RE: **Robinson Tract Residential Development
Westtown Township, Chester County, PA
McMahon Project No. 816451.11**

McMahon Associates, Inc. is in receipt of the Township's comment letter, prepared by Albert Federico Consulting, LLC and last revised July 6, 2020, in regards to the *Transportation Impact Study for the Robinson Tract*, prepared by our office and last revised May 15, 2020. The development is proposed to be located on the Crebilly Farm property along the west side of U.S. Route 202 (Wilmington Pike), between West Pleasant Grove Road and Street Road (S.R. 0926), in Westtown Township, Chester County, Pennsylvania. On behalf of the applicant, below is a summary of the outstanding comments in italics, with our responses following each comment.

Response to Comment 1ai
Table 1, page 4

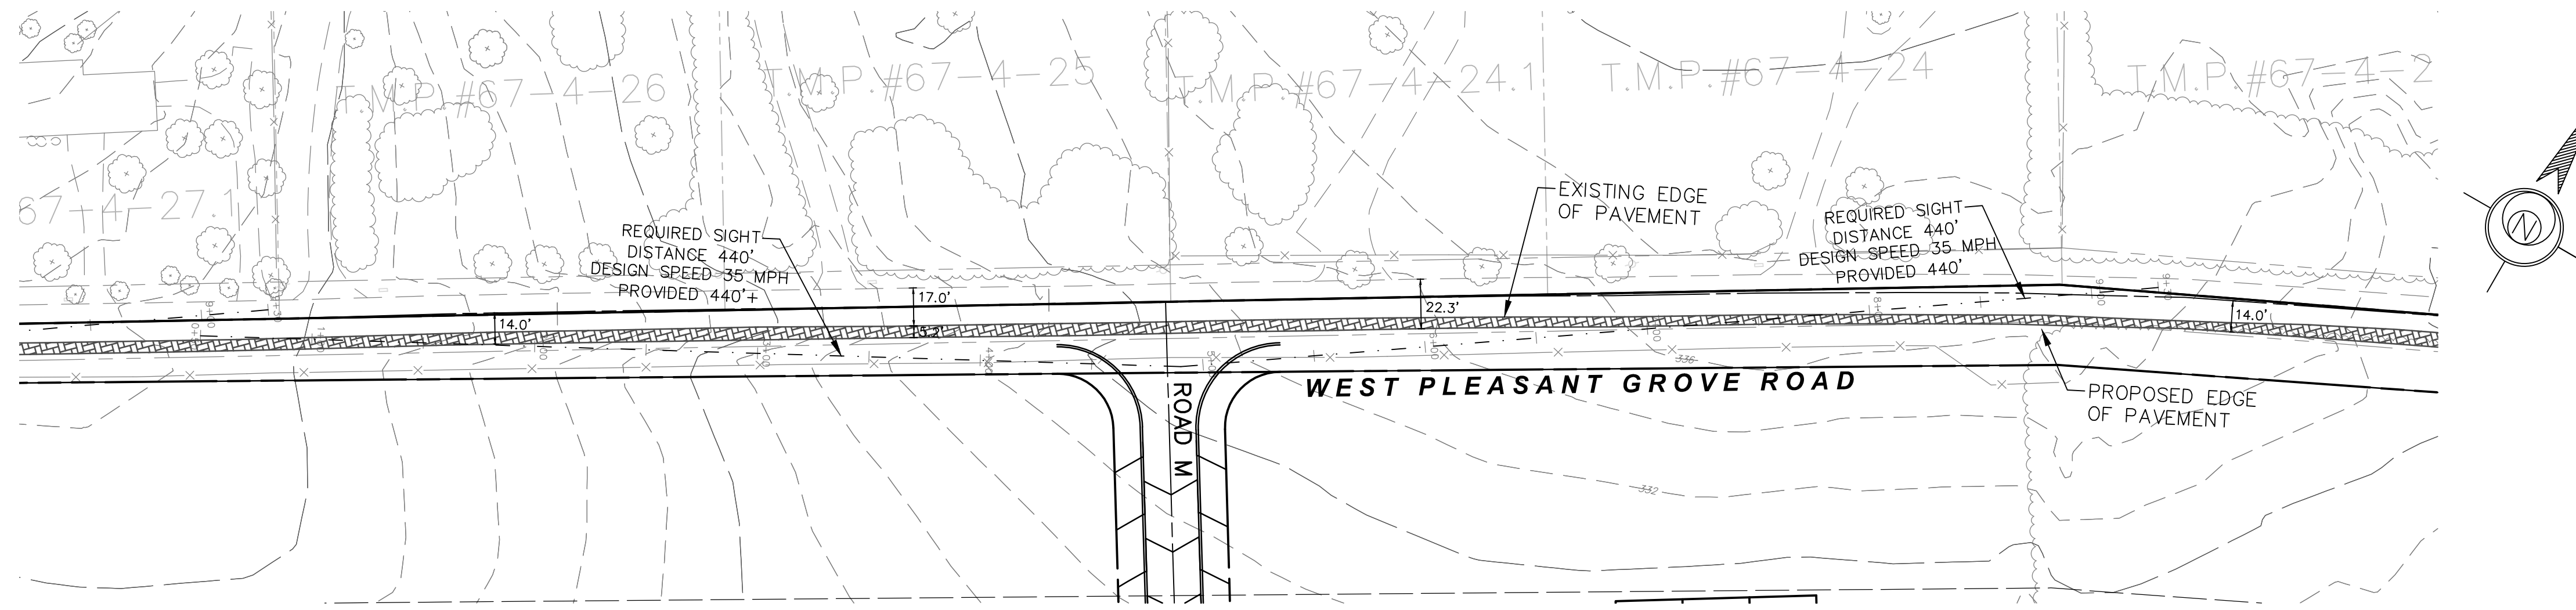
*Comment #1ai: Table 1 should be updated to identify West Pleasant Grove Road as a Township Collector Roadway {Westtown Township Comprehensive Plan update, page 9-7}
Status: This comment remains outstanding. Westtown Township identifies West Pleasant Grove as a Collector Road and the Study should be revised accordingly.*

Response: A revised Table 1 is attached which identifies West Pleasant Grove Road as a Collector Roadway that is substandard, as it does not currently meet the Township's design criteria for this classification.

SIGHT DISTANCE PLAN AND PROFILE
WEST PLEASANT GROVE RD AND ROAD 'M'

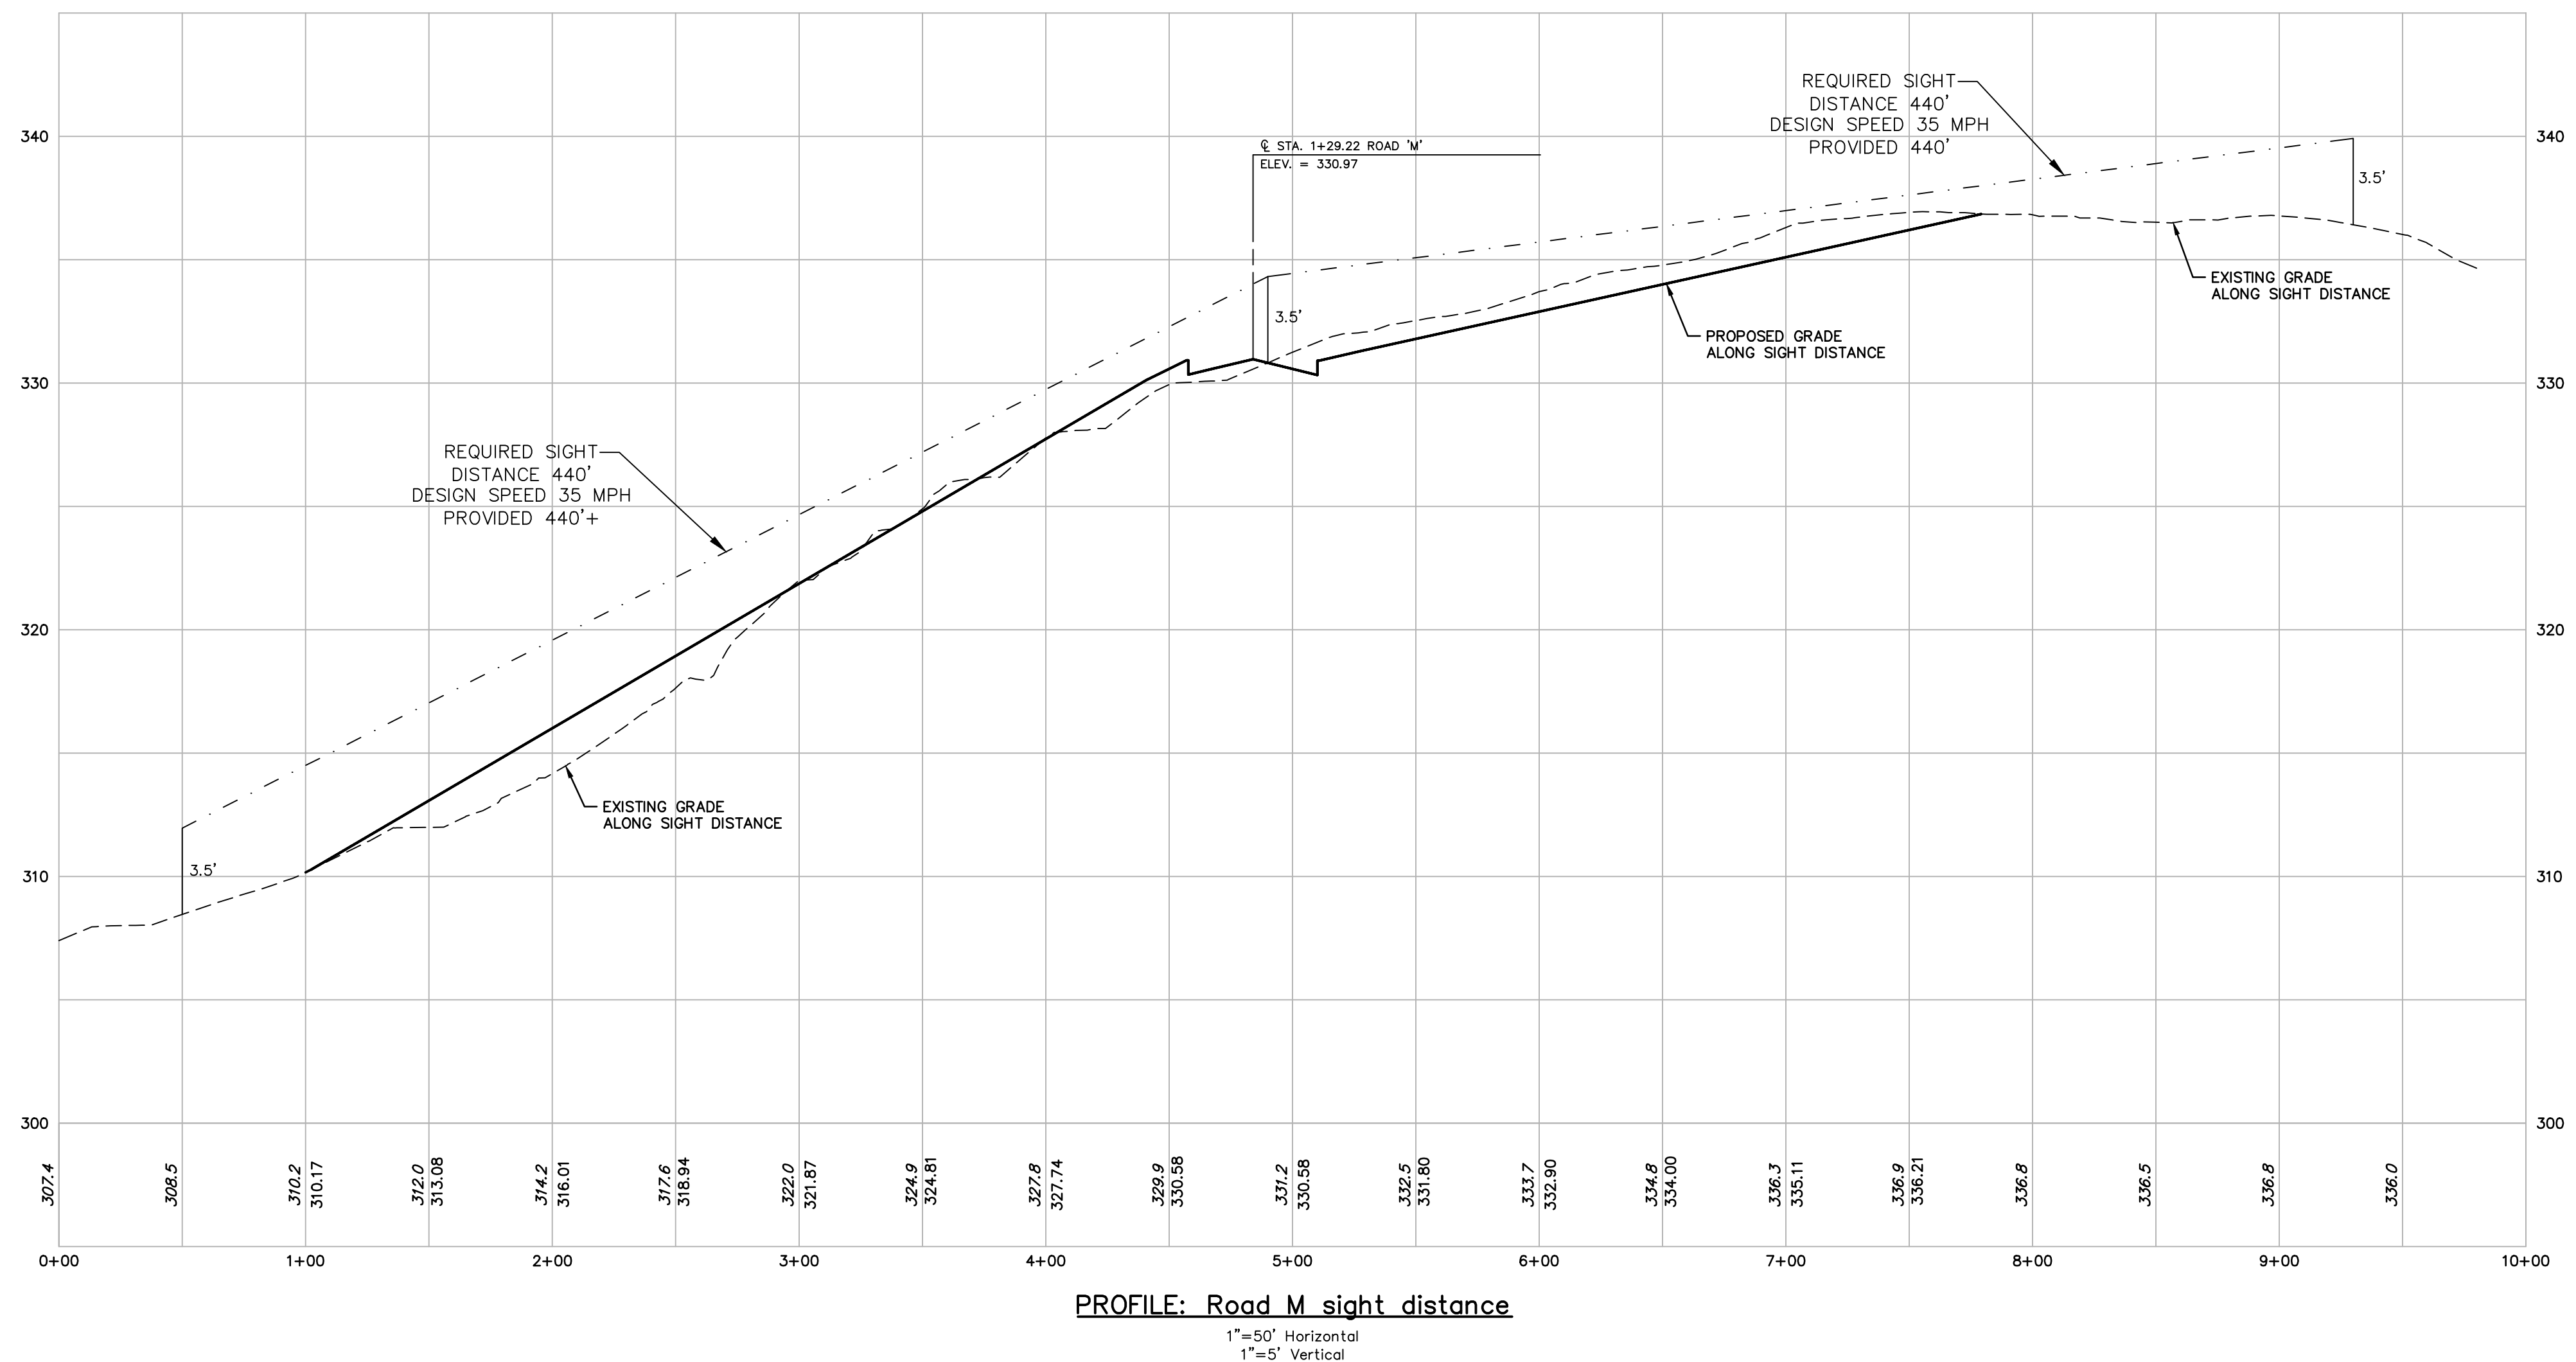
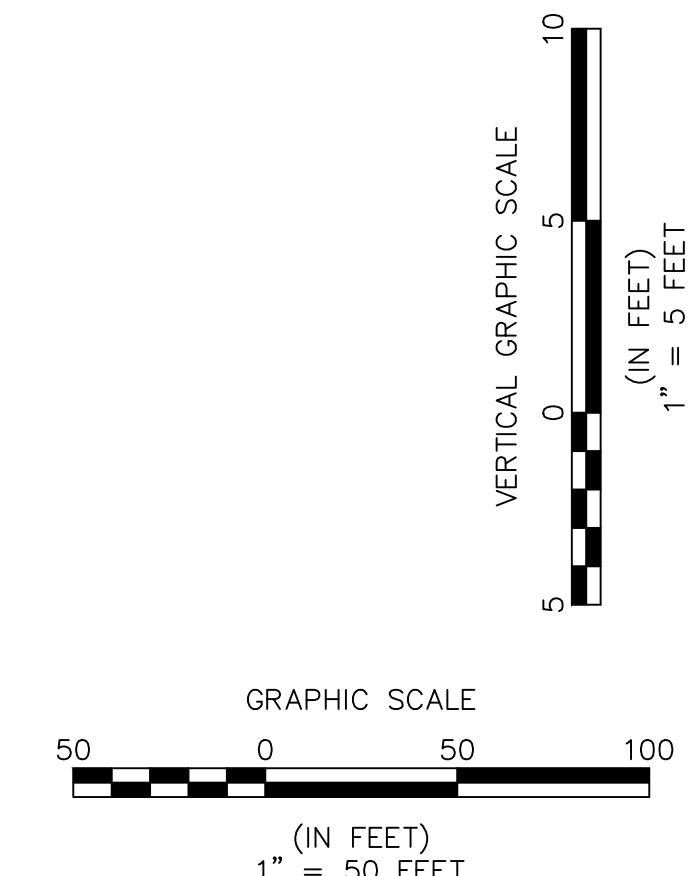
Comment #1aiii: As previously noted, the scope of physical improvements required to provide acceptable sight distance to public roads should be clearly indicated on the plans.

Status: This comment remains outstanding. The limits of clearing and/or other improvements required to provide adequate sight distance should be illustrated on the plans to allow the Planning Commission to consider potential impacts. Further, it does not appear that the analyses have been updated to consider required roadway widening.

Response: Sight distance profiles are attached, illustrating both the preliminary horizontal and vertical design with inclusion of the roadway improvements that the applicant is providing. These profiles demonstrate that acceptable sight distance is achieved for all proposed access intersections.

Response to Comment 2ai
US 202 and West Pleasant Grove Concept

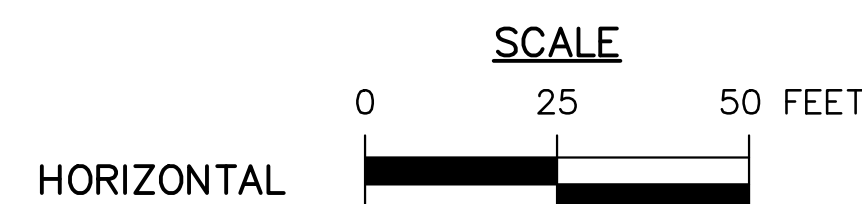
Comment #2ai: The Applicant has indicated that turn lanes will be provided to accommodate post development volumes at the following intersections, but these improvements are not reflected on the submitted plans:
(1) PA Route 926 at New Street
(2) US Route 202 at Pleasant Grove Road
Status: Supplemental exhibits for the improvement of PA Route 926 and New Street have been provided to the Township and PennDOT. US Route 202 and West Pleasant Grove Road remains outstanding.

Response: An exhibit illustrating the provision of a dedicated southbound US 202 right-turn lane at West Pleasant Grove Road is attached. All proposed improvements can be constructed within the PennDOT Right-of-Way.
